UNITED STATES
NUCLEAR REGULATORY COMMISSION
WASHINGTON, D. C. 20555

MEMORANDUM: Robert E. Browning, Director
Division of Waste Management

FROM: F. Robert Cook, Senior On-Site License
Representative, Basalt Waste Isolation
Project (BWIP)

SUBJECT: OBSERVATIONS, COMMENTS AND RECOMMENDATIONS
FOR THE PERIOD JANUARY 17 TO APRIL 3, 1987

Project No. 13891C	WASHINGTON PUBLIC POWER SUPPLY SYSTEM	SHALLOW MICROEARTHQUAKE SWARM OF 2 AUGUST 1979	
Woodward-Clyde Consultants

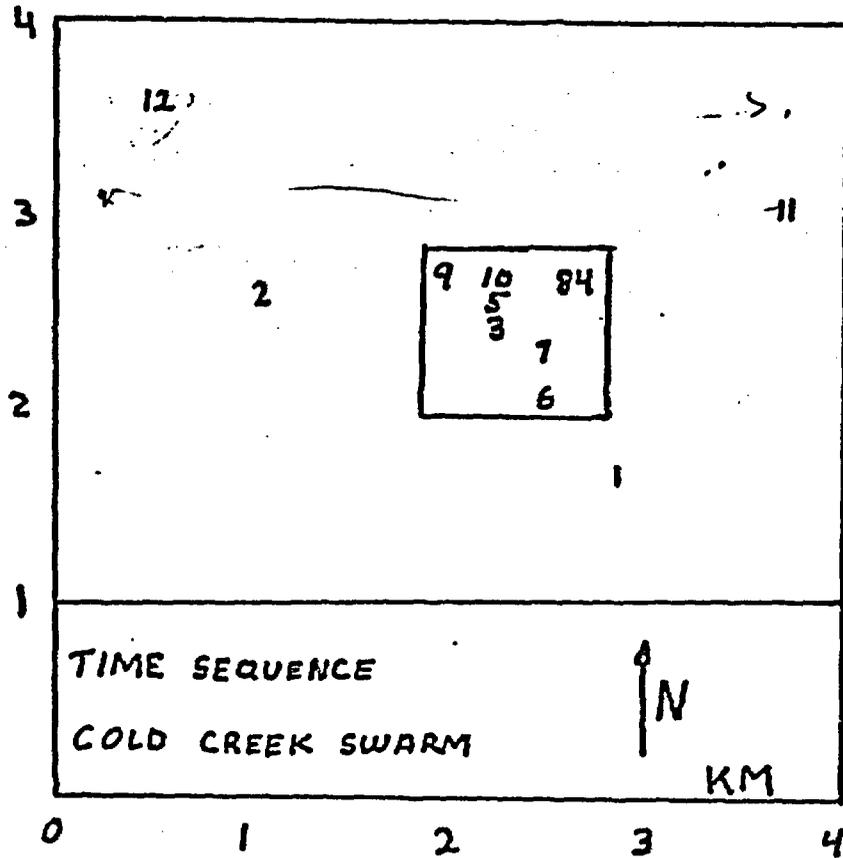
Long plotted wrong

EXTERNAL GOVERNING DOCUMENT

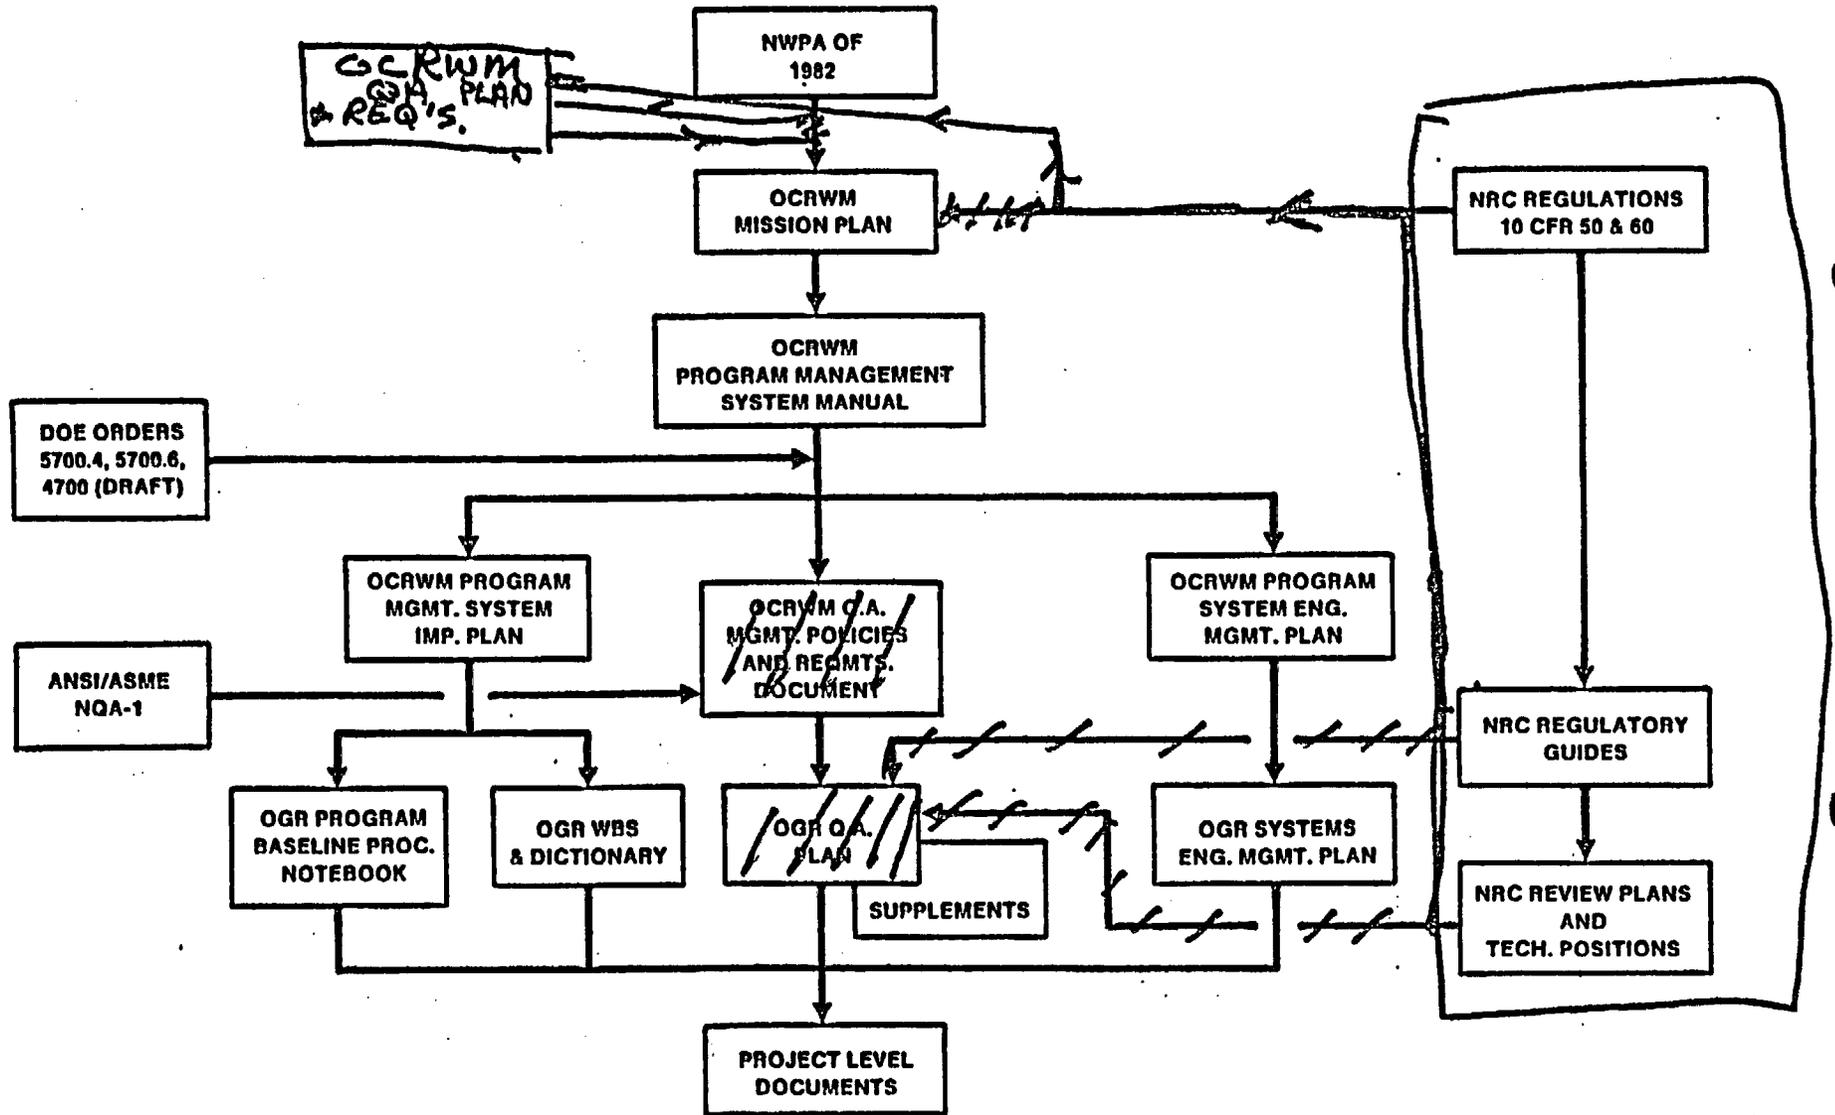
contained in NQA-1 at a level above the Appendix B requirements as supplemented by the QA Review Plan. Attachment F identifies the current hierarchy of requirements for DOE/HQ and DOE/RL, marked-up to reflect the possible correction noted herein.

Also it should be noted that the requirements stemming from the Mission Plan appear in the hierarchy presented by DOE at a higher level than the quality assurance plan. Since the Mission Plan is in part a scheduling document, which schedule results from coordinating funding restraints and technical requirements and procedures in order to achieve quality in the technical products of the project, it is incorrectly placed in the hierarchy as indicated in the mark-up of Attachment F. In particular the schedular part of the Mission Plan should not appear to the participants as a requirement, if quality of the technical products is to be preserved.

To correct this situation I consider that the hierarchy of requirements documents should clearly list the quality assurance program requirements at the top with lower tier management requirements and procedures and systems engineering requirements and procedures as subsidiary documents. Hence basic orders which DOE specifies for the BWIP, for example, DOE 5700 series orders, should be considered as part of the project's quality assurance program required by the rules of Part 60, assuming the various DOE orders do not conflict with the NRC rules. (Currently there may be conflicts between the requirements of the DOE orders and the requirements of Part 60/50 Appendix B, particularly in so far as these orders specify various quality assurance requirements

EXTERNAL GOVERNING DOCUMENT

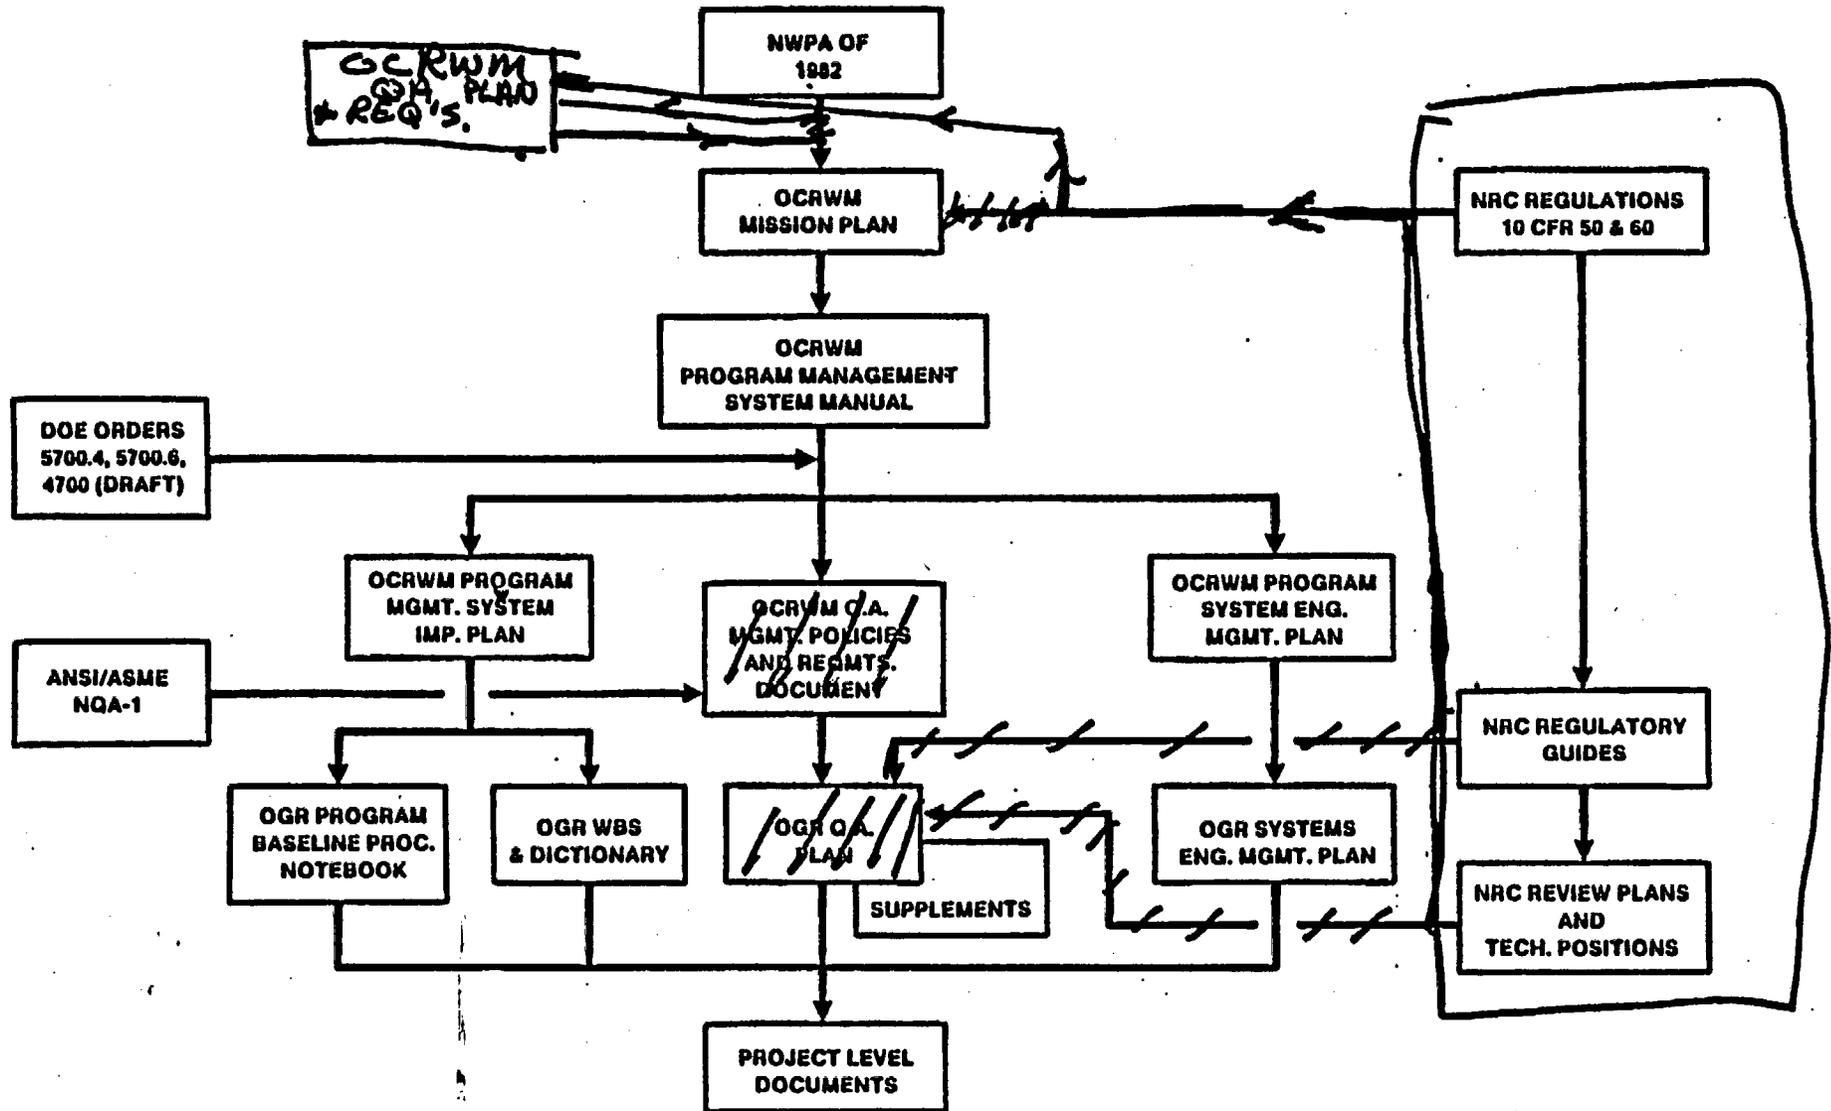
contained in NQA-1 at a level above the Appendix B requirements as supplemented by the QA Review Plan. Attachment F identifies the current hierarchy of requirements for DOE/HQ and DOE/RL, marked-up to reflect the possible correction noted herein.

Also it should be noted that the requirements stemming from the Mission Plan appear in the hierarchy presented by DOE at a higher level than the quality assurance plan. Since the Mission Plan is in part a scheduling document, which schedule results from coordinating funding restraints and technical requirements and procedures in order to achieve quality in the technical products of the project, it is incorrectly placed in the hierarchy as indicated in the mark-up of Attachment F. In particular the schedular part of the Mission Plan should not appear to the participants as a requirement, if quality of the technical products is to be preserved.

To correct this situation I consider that the hierarchy of requirements documents should clearly list the quality assurance program requirements at the top with lower tier management requirements and procedures and systems engineering requirements and procedures as subsidiary documents. Hence basic orders which DOE specifies for the BWIP, for example, DOE 5700 series orders, should be considered as part of the project's quality assurance program required by the rules of Part 60, assuming the various DOE orders do not conflict with the NRC rules. (Currently there may be conflicts between the requirements of the DOE orders and the requirements of Part 60/50 Appendix B, particularly in so far as these orders specify various quality assurance requirements
